## Product Advisory (PA)

**Subject:** Name/Logo replacement of IDT packing and shipping label by Renesas Logo/name.

Appendix A – Example of Renesas Name/Logo Replacement

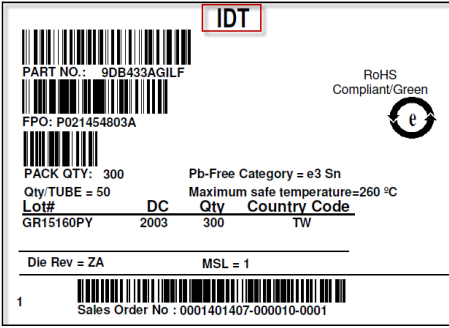
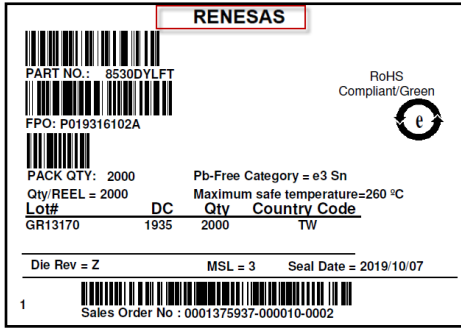
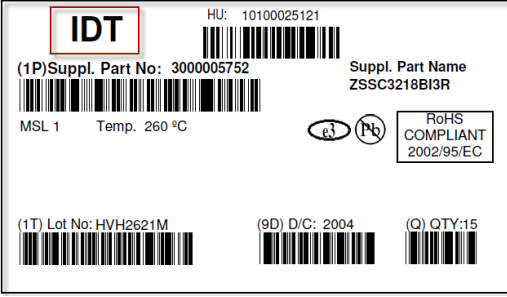
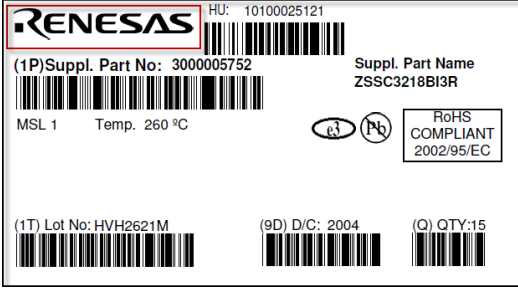
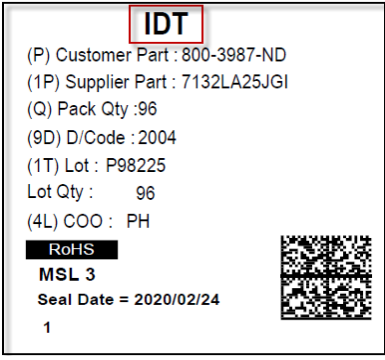
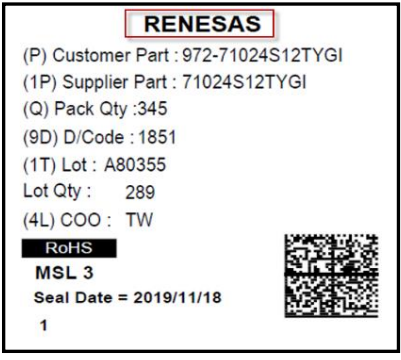
Renesas Electronics Germany GmbH (formerly known as IDT Europe GmbH) and Renesas Electronics (Penang) Sdn Bhd (formerly known as IDT Malaysia Sdn. Bhd ) will replace IDT Name/Logo with Renesas Name/Logo on packaging material (shipping tube & packing box) , shipping documents and labels effective 1 Apr 2020.

Refer Appendix A for example of logo/name replacement.
